AGENDA
Regular Hybrid Meeting
Town of Granby
Planning & Zoning Commission
Tuesday, June 24, 2025, at 7:00 pm
Town Hall Meeting Room

RE: Application seeking a Site Plan and Special Permit under Zoning Regulations Sections 3.5.4.3, 8.6.14 and 8.21.4 for a commercial building in the Aquifer Protection Overlay Zone with an illuminated freestanding directory sign and outdoor storage, for property located at 14 Mill Pond Drive, C2 Zone: File Z-7-25.

Site Plan Review

Plan: "Proposed Commercial Facility, #14 Mill Pond Drive, Granby, Connecticut 06035, May 2, 2025, Biff Schechinger, Landscape Architect, Revised 4 June 2025, marked up copy revised 6/18/2025."

Survey S.1

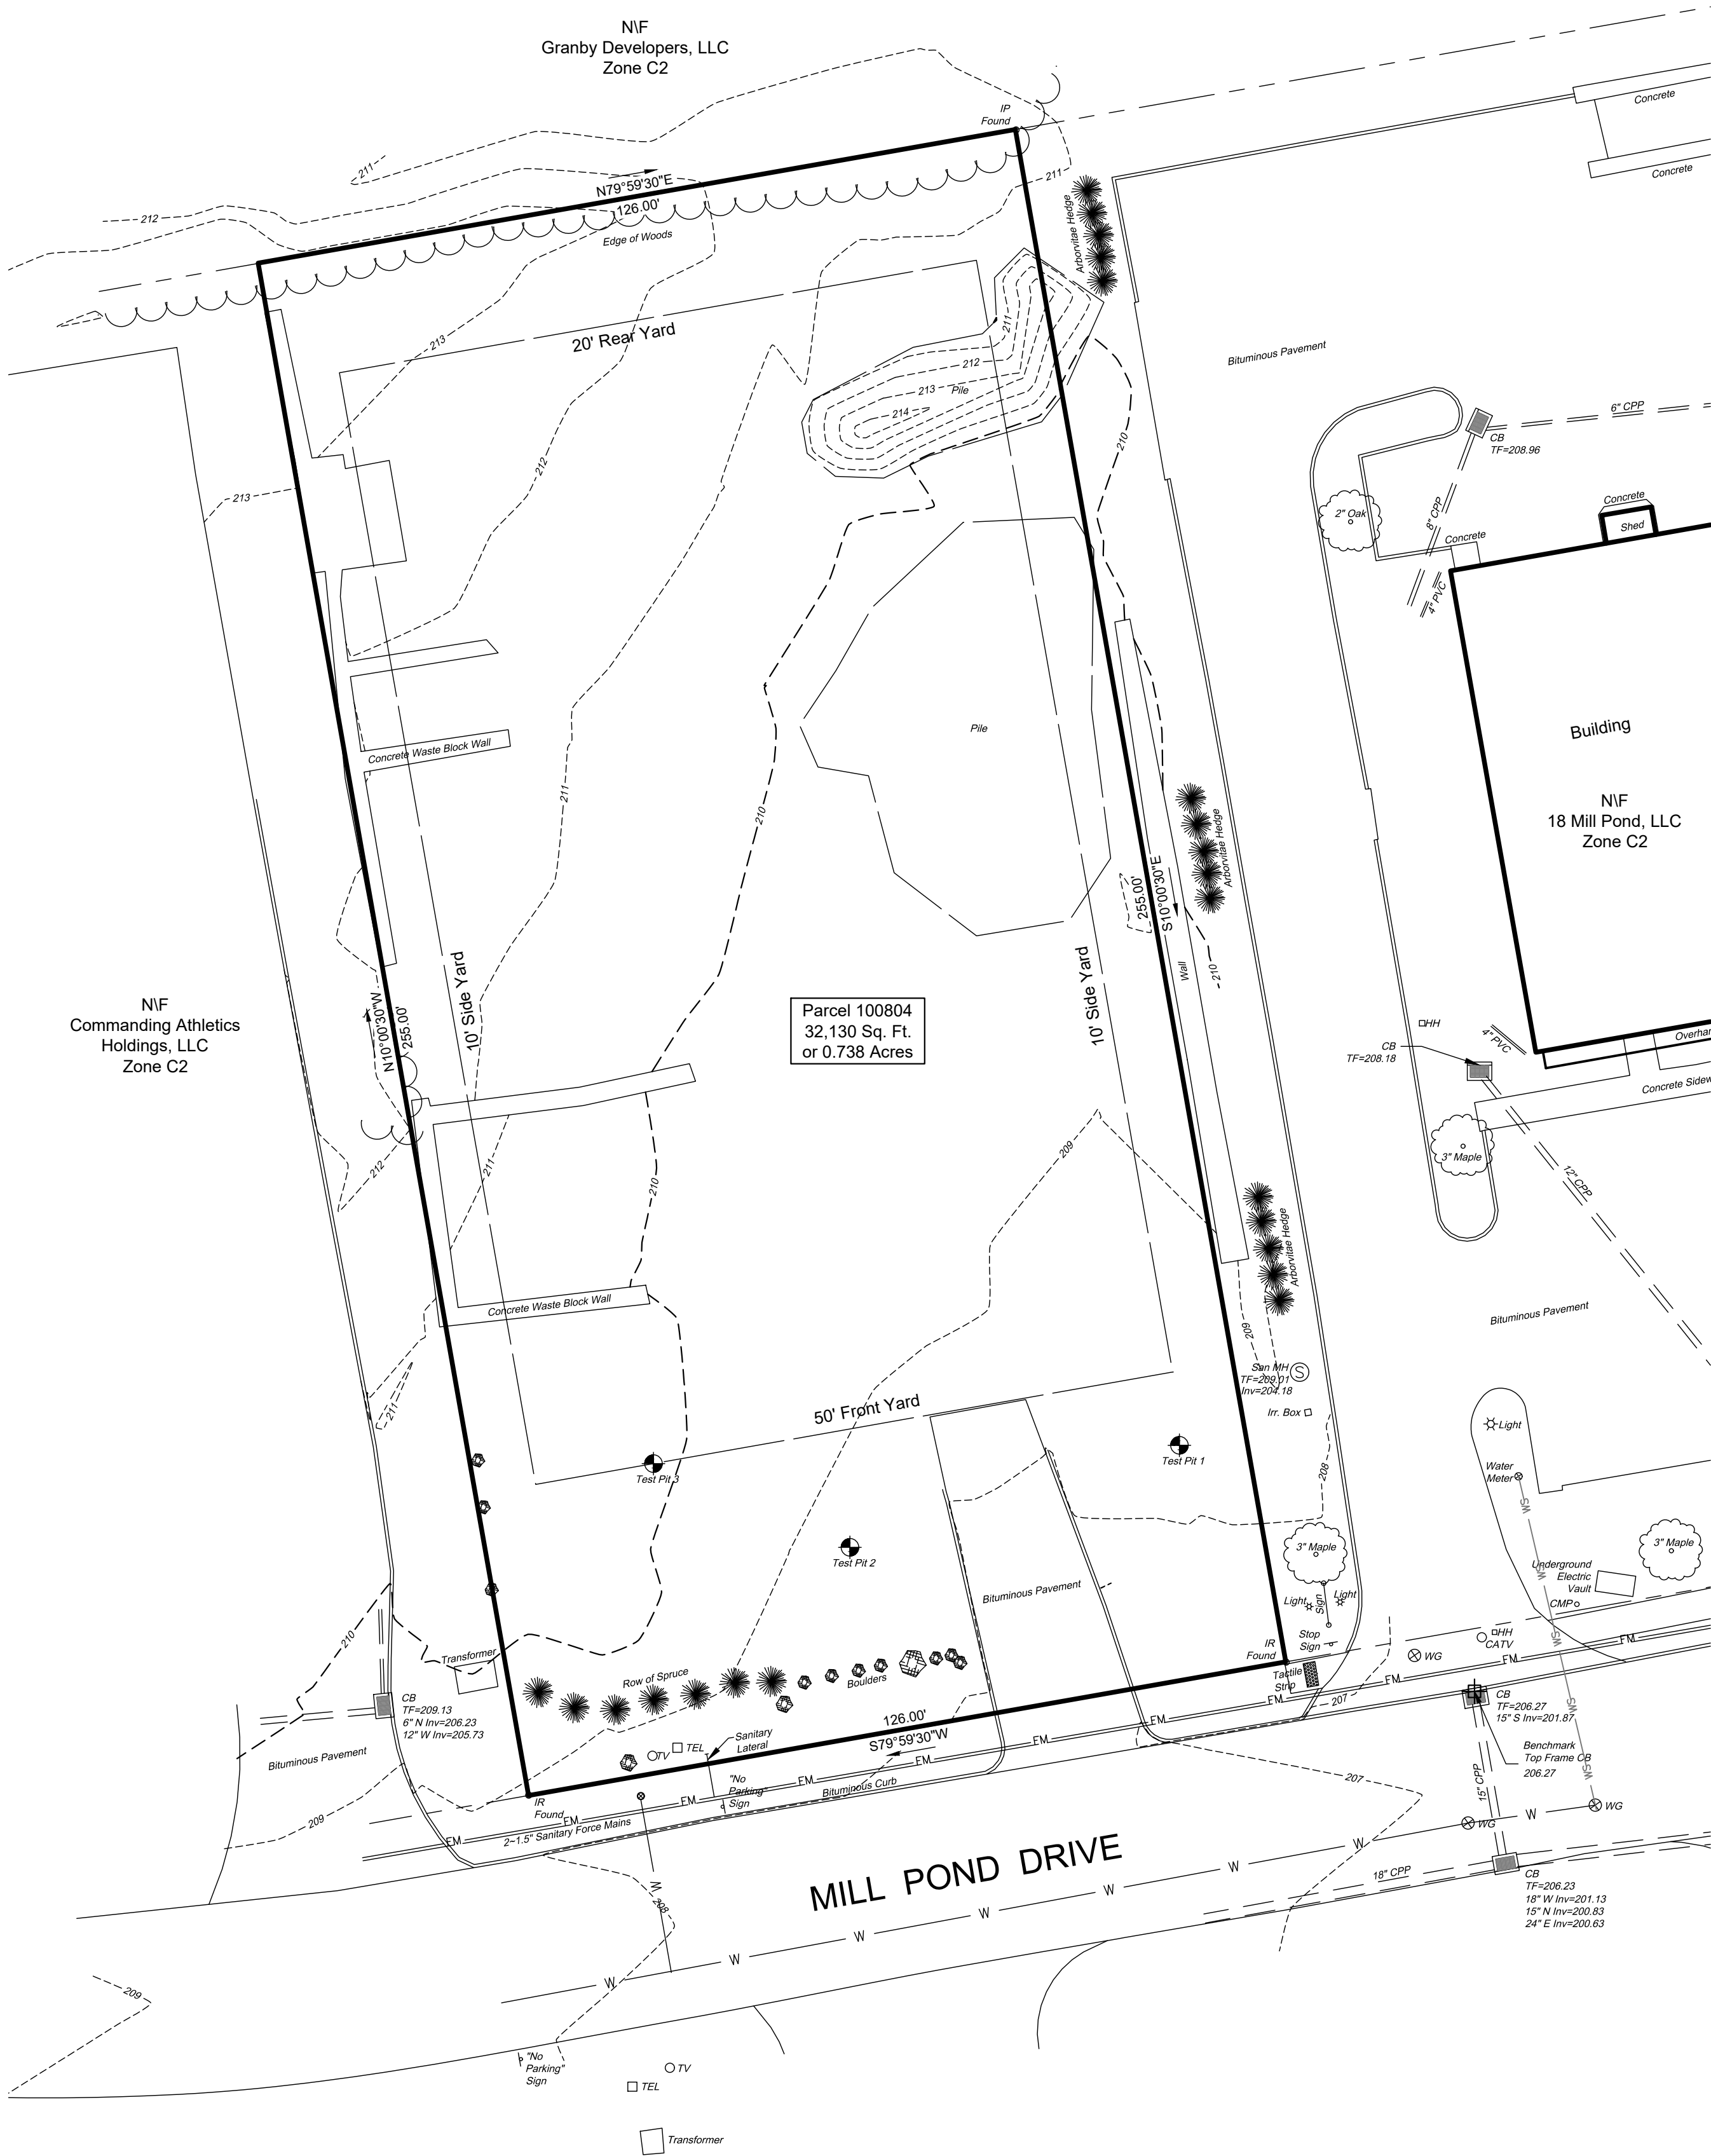
4. Show a benchmark with datum.

Drawing Title:
Proposed Commercial Facility:
#14 MILL POND DRIVE, GRANBY, CT
S & E CONTROL & UTILITIES PLAN

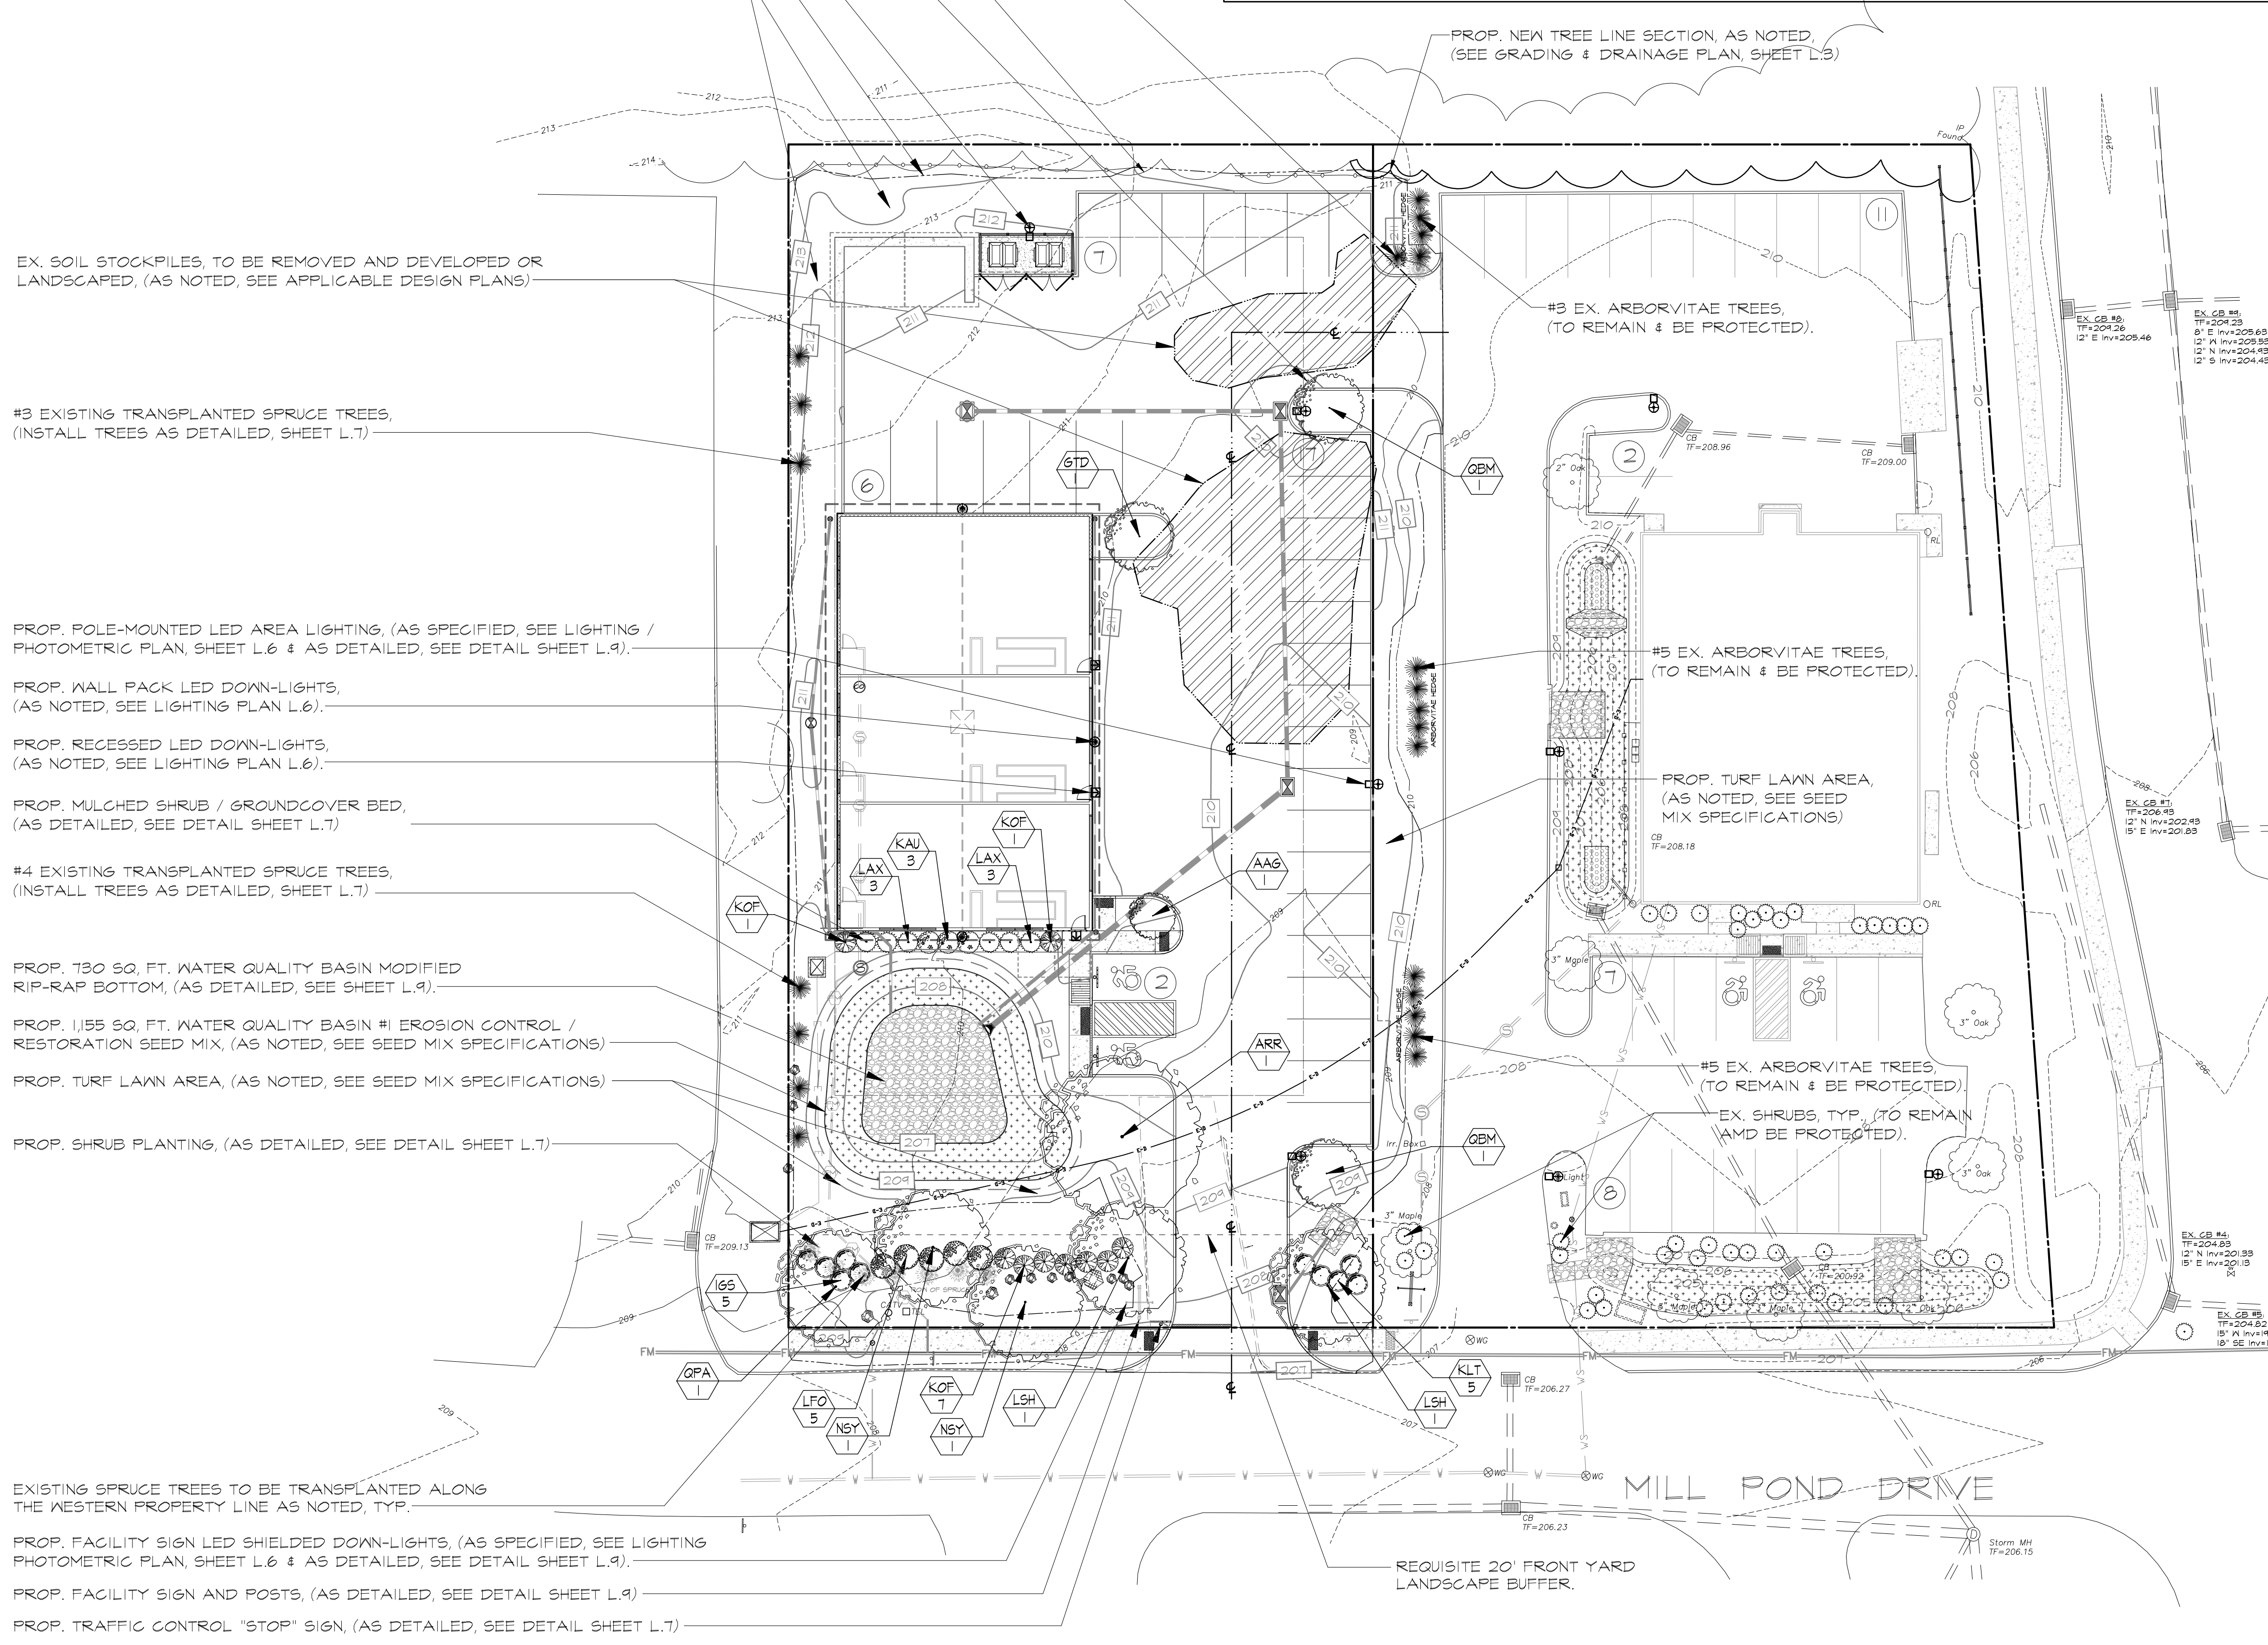
23. Sanitary sewer has been re-routed as requested. Suggest moving proposed pump station close to the building with a force main to the street.
26. Regarding the Water Quality Basin Preparation Notes, compacted fill is not to be placed in the infiltration portion of the basin. In the "Water Quality Basin Preparation Note," remove reference to placing compacted fill in the basin.
28. A project narrative is required for erosion and sediment control plans. See chapter 3 page 44 of Connecticut Guidelines for the information required. For this project include items i through vii. Refer to the latest manual effective March 30, 2024.
30. Reference the current Connecticut Guidelines for Soil Erosion and Sediment Control.
